Abnormal ("Squeak") Noise From Rear Suspension Over Uneven Road

Service Category Suspension

Section Rear Suspension

YEAR(S)	MODEL(S)	ADDITIONAL INFORMATION
2014	Highlander, Highlander HV

Figure 1.

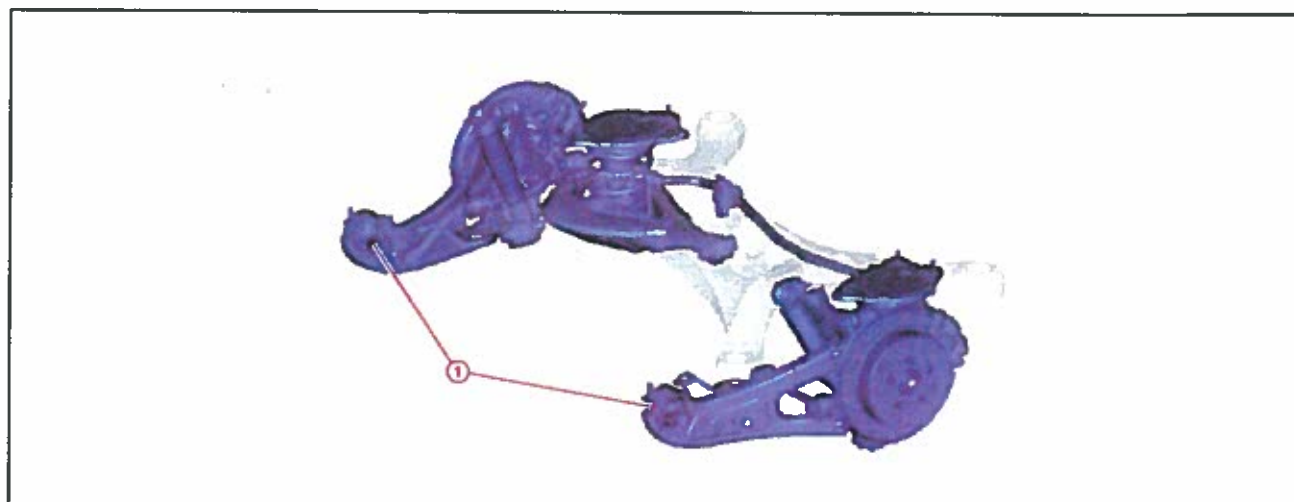
Some 2014 model year Highlander and Highlander HV vehicles may exhibit an abnormal noise, like a "squeak/squawk/groan" type noise, from the rear suspension when traveling over uneven roads which may become more pronounced in colder ambient temperatures. The abnormal noise may be caused by the Rear Trailing Arm bushing. An updated Rear Trailing Arm Assembly is available. Follow the Repair Procedure in this bulletin to address this condition.

3. Replace BOTH Rear Trailing Arm Assemblies even if only one side is emitting the "squeak/squawk/groan" type noise.

Figure 2.

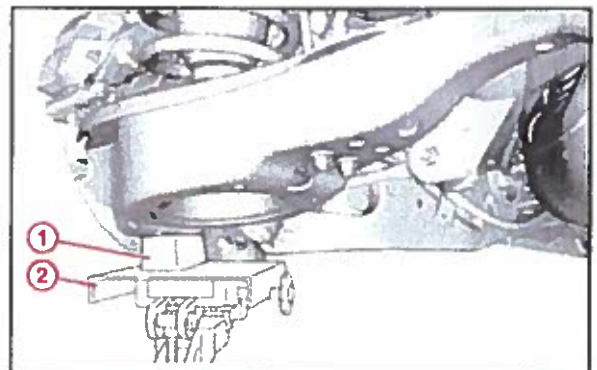
Support the rear No. 2 suspension arm assembly until reinstallation of the Rear Trailing Arm Assembly is complete.
